**Agenda**  
**City of Springboro Planning Commission Meeting**  
**Wednesday, April 12, 2023, 6:00 p.m.**  
**Council Chambers, City Building, 320 West Central Avenue**

**Site Plan Review, 25 West Central Avenue (SR 73), River Valley Credit Union, ATM/ITM for new branch office**

City staff recommends approval of the site plan for the proposed ATM/ITM for River Valley Credit Union, 25 West Central Avenue, with the following comments:

## EXISTING ARCHITECTURAL SITE PLAN

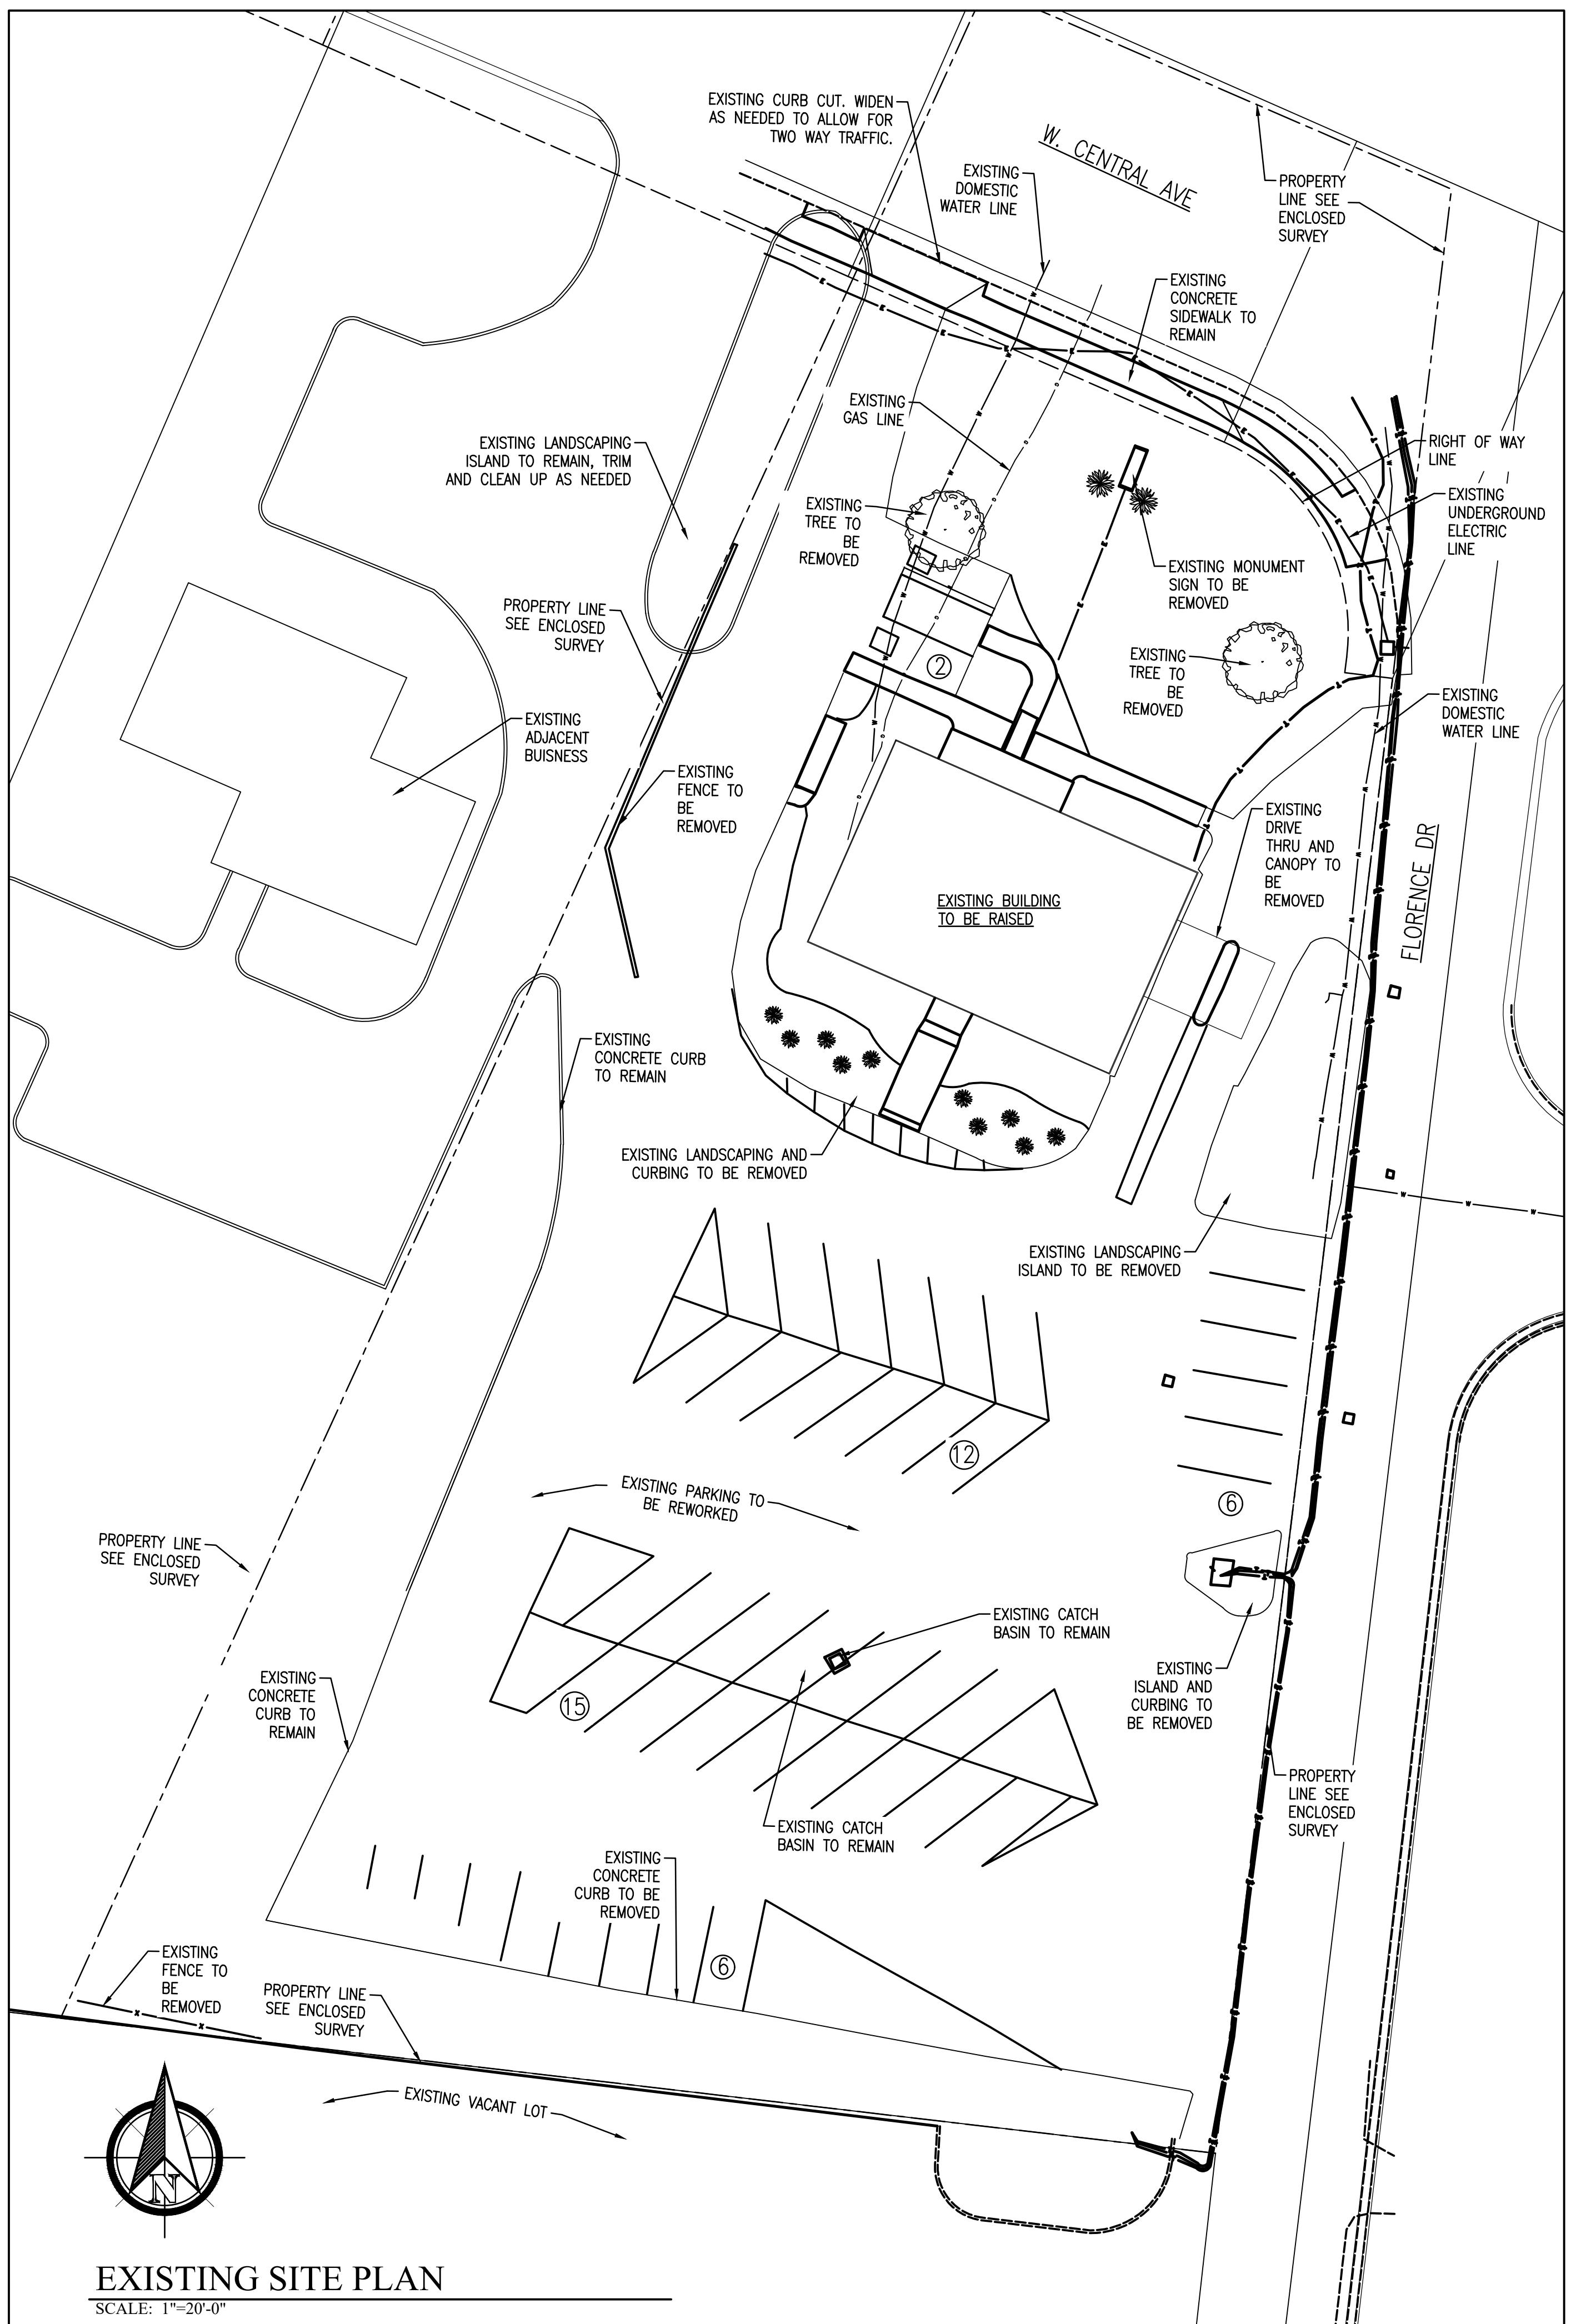
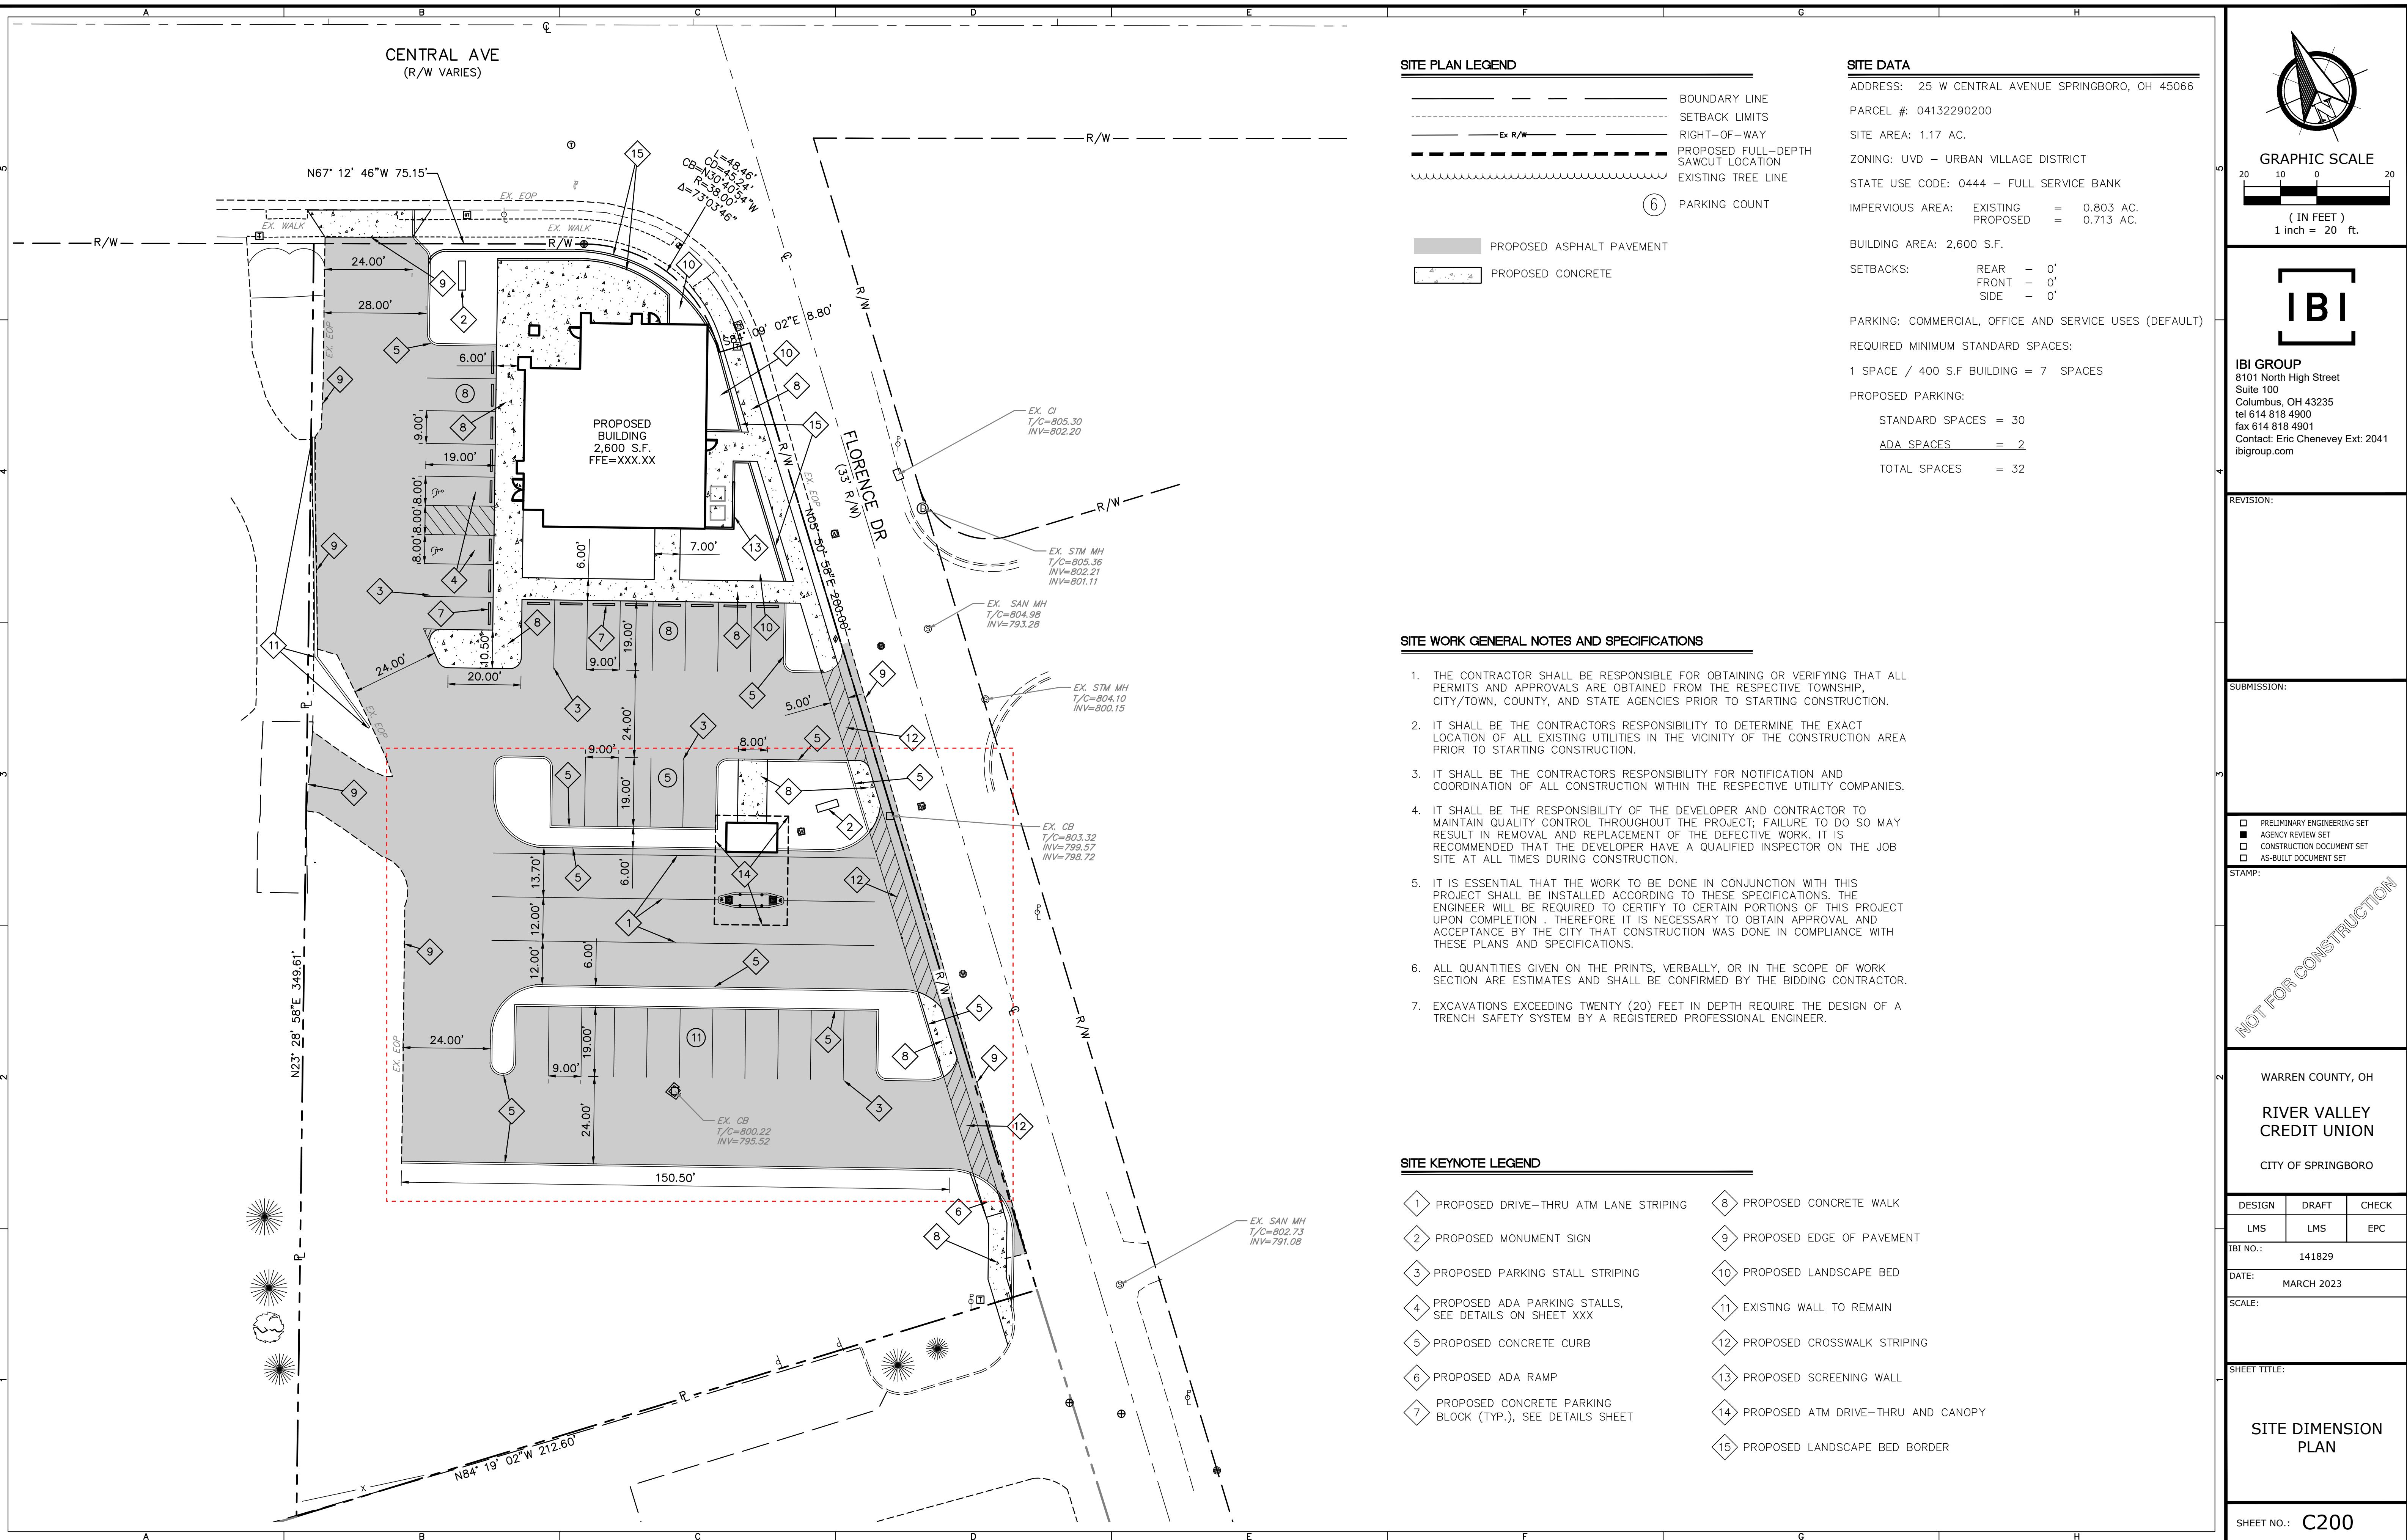
2. Verify material match between proposed ATM/ITM building and new branch location (to be reviewed separately).
3. Extend curb and gutter to south property line, with storm sewer and add public concrete sidewalk the entire length. Create a concrete apron section for the curb cuts to include sidewalk. Dedicate additional right-of-way to include the curb and gutter section and sidewalk.

4. Provide proposed water lateral and sewer lateral details.
5. Other engineering comments reserved until the submission of engineered design drawings.
6. Provide pre- and post-impervious area to verify the need for storm water detention.

7. Tie down location of ATM/ITM. Move the structure at least 10 feet away from existing storm sewer.
8. Add directional arrow pavement marking for drive thru aisles.
